Re: Docket No. 461A - CSC 461A Greenwich Substation and Line Project - Petition for Reconsideration

Response to CSC-01 Interrogatories dated 06/12/2017

Simplified 13.2kV Proposal

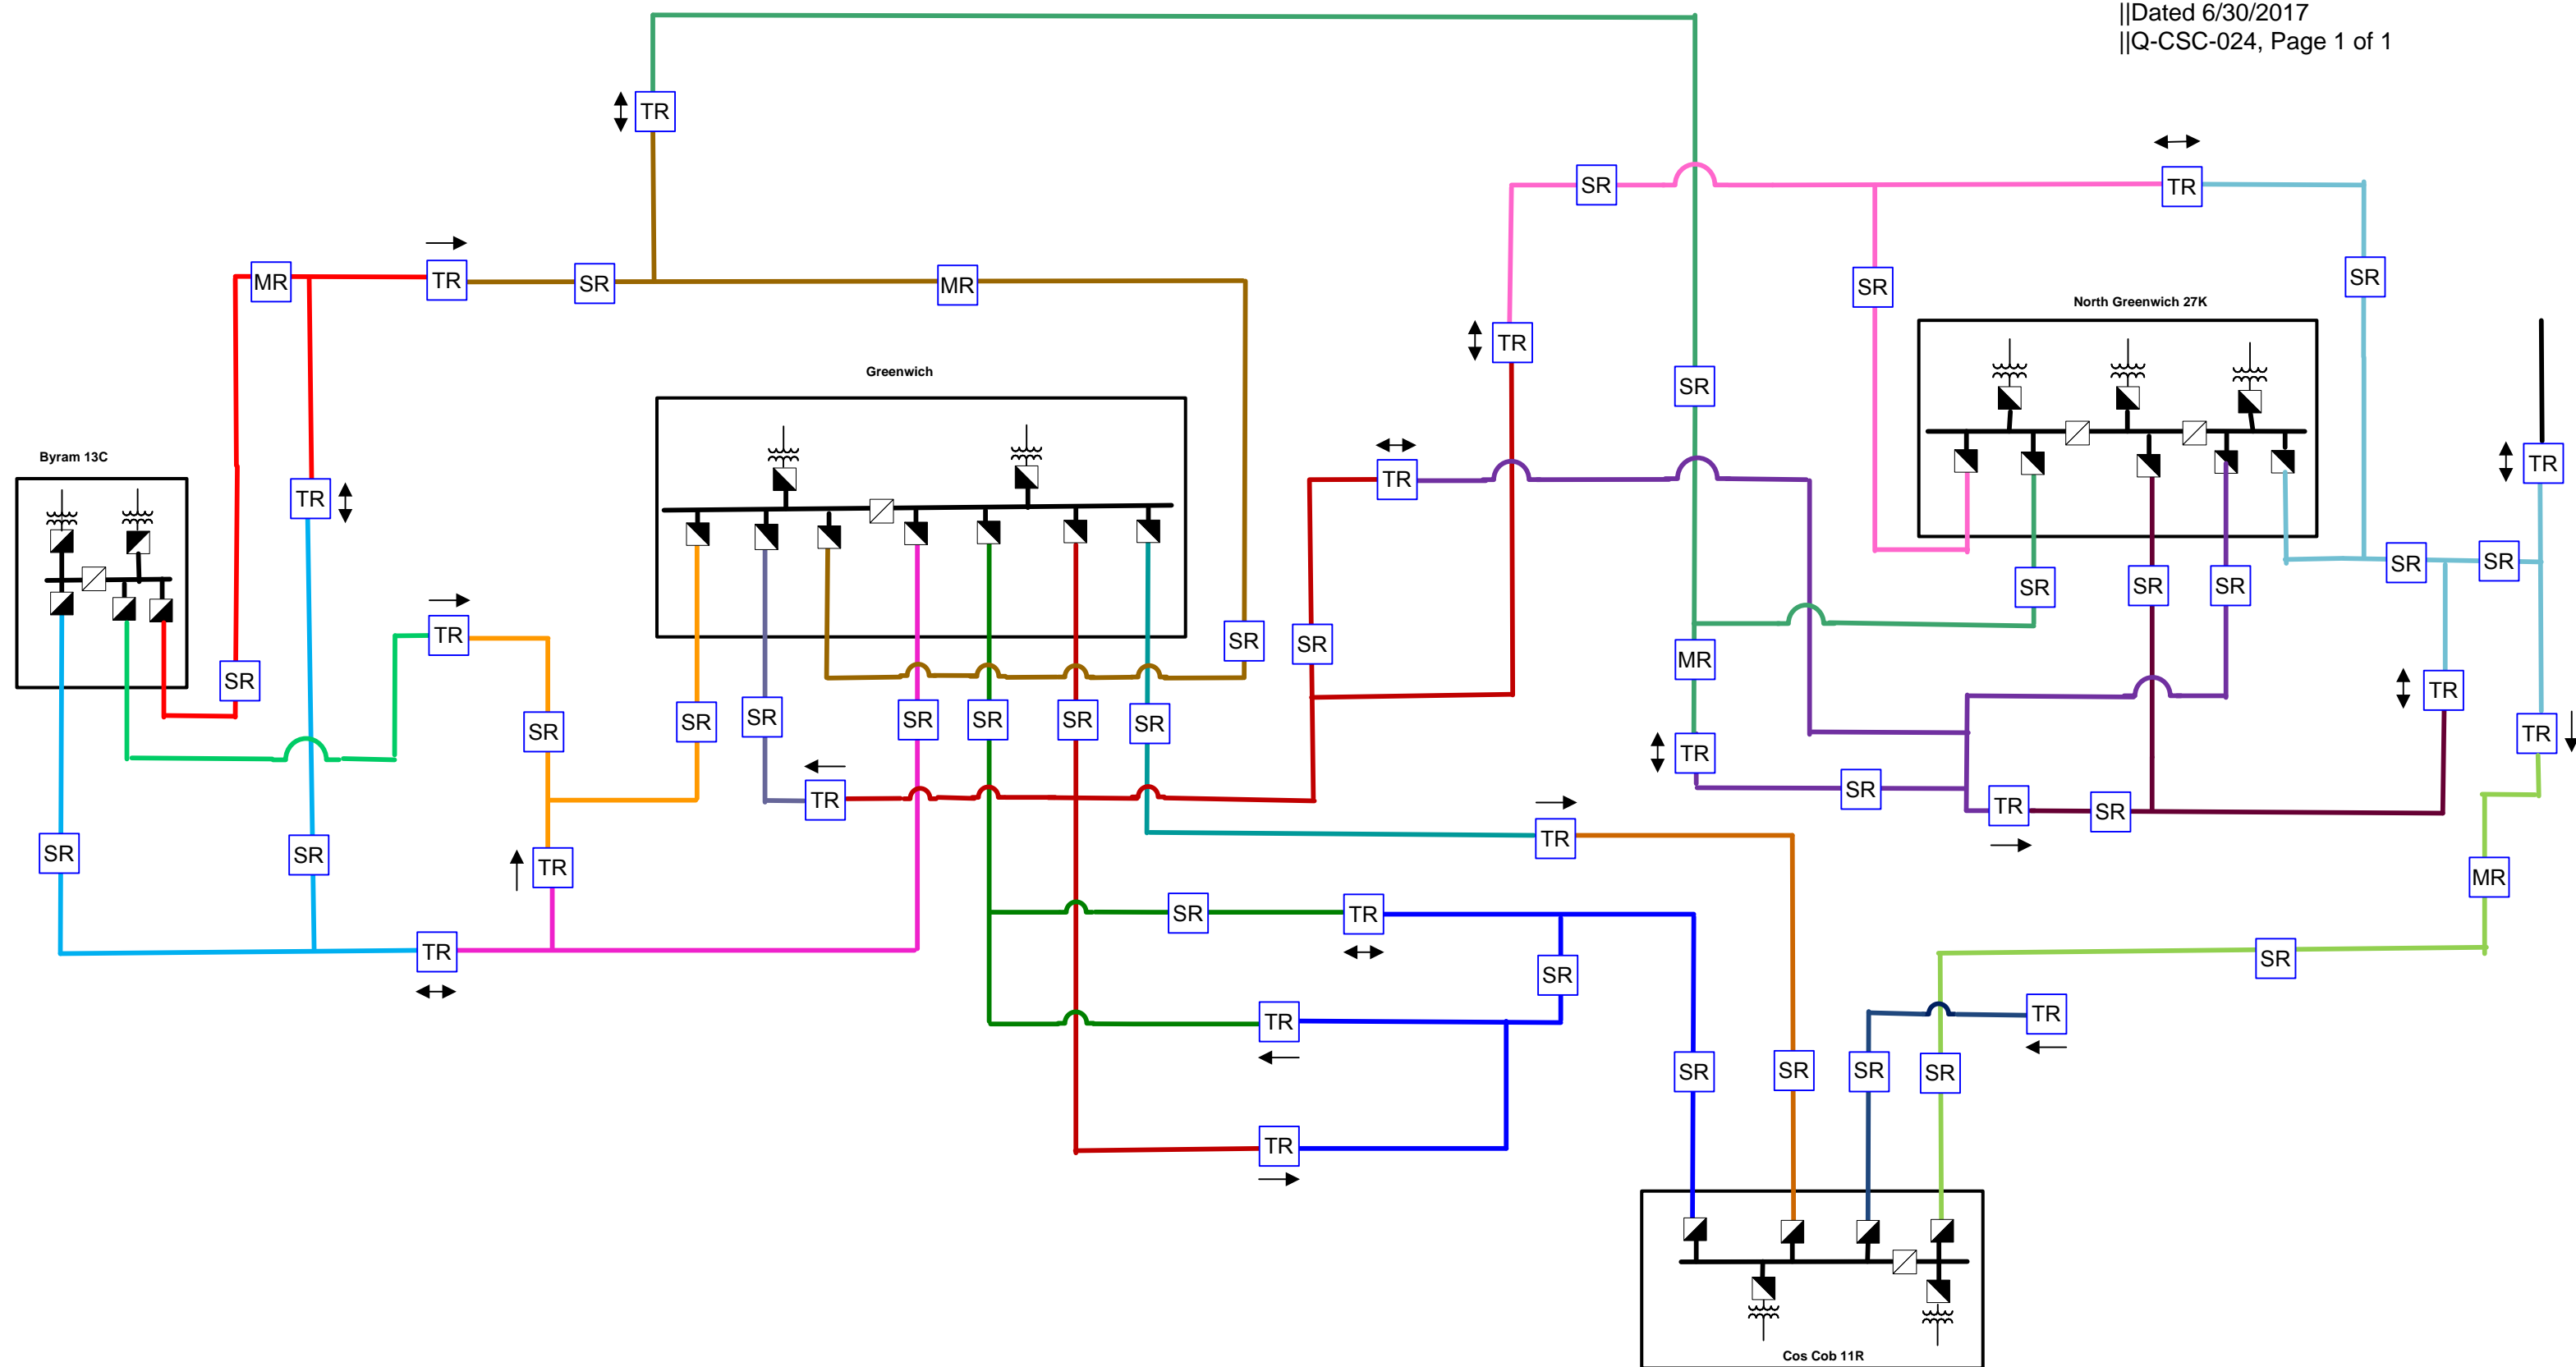
Reference Eversource Response to OCC – 058, 11/30/15. Revise the information in the response based on the new Greenwich Substation configuration.

- A. Define/describe planned feeder ties between the two substations.
 - a. Please refer to the Simplified Greenwich 13.2 kV System Proposed Design attached. The Proposed Greenwich Substation would have [six] two automatic loop scheme ties between feeders emanating from different buses at the proposed Greenwich Substation, four automatic loop scheme ties with Cos Cob Substation, [and] three automatic loop schemes with North Greenwich Substation, and three automatic loop schemes with Byram Substation.

- iii. The proposed Greenwich Substation would have automatic loop schemes ties with North Greenwich feeders and automatic loop scheme ties between proposed Greenwich feeders that would be fed by different substation buses, different substations' transformers and different substation transmission lines. The proposed Greenwich Substation feeders will have redundant backup between themselves. The only vulnerability would be if both transmission lines from Cos Cob Substation to the proposed Greenwich Substation were lost. In this situation. North Greenwich Substation would back up most of the load of Greenwich Substation feeders via the 13.2 kV system.
